- Page 2E-46 – Added the following information on “Surplus Right of Way”;
DETERMINING SURPLUS RIGHT OF WAY

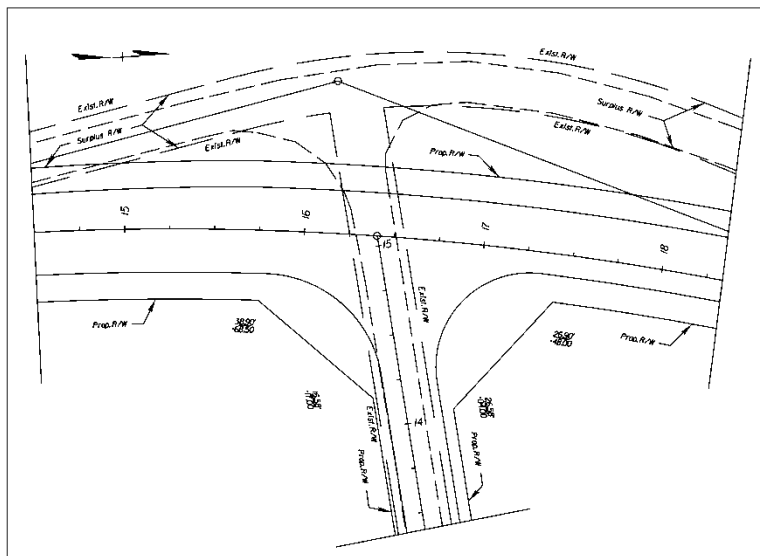
- Page 2E-48 – Revised “FIGURE 2E-9 DEPICTING LIMITED ACCESS RIGHT OF WAY” detail to refer to Appendix F for spacing standards.
- Page 2E-49 – Replaced “FIGURE 2E-10 DEPICTING LIMITED ACCESS RIGHT OF WAY”.
- Pages 2E-50 thru 2E-52 – Replaced the Title Sheet examples with new examples of Tier 1 and Tier 2 projects, page numbers now 2E-50 thru 2E-55.
- Page 2E-72 – Replaced “FIGURE 2E-17 SAMPLE RIGHT OF WAY DATA SHEET to reflect change to add easements for entrances.
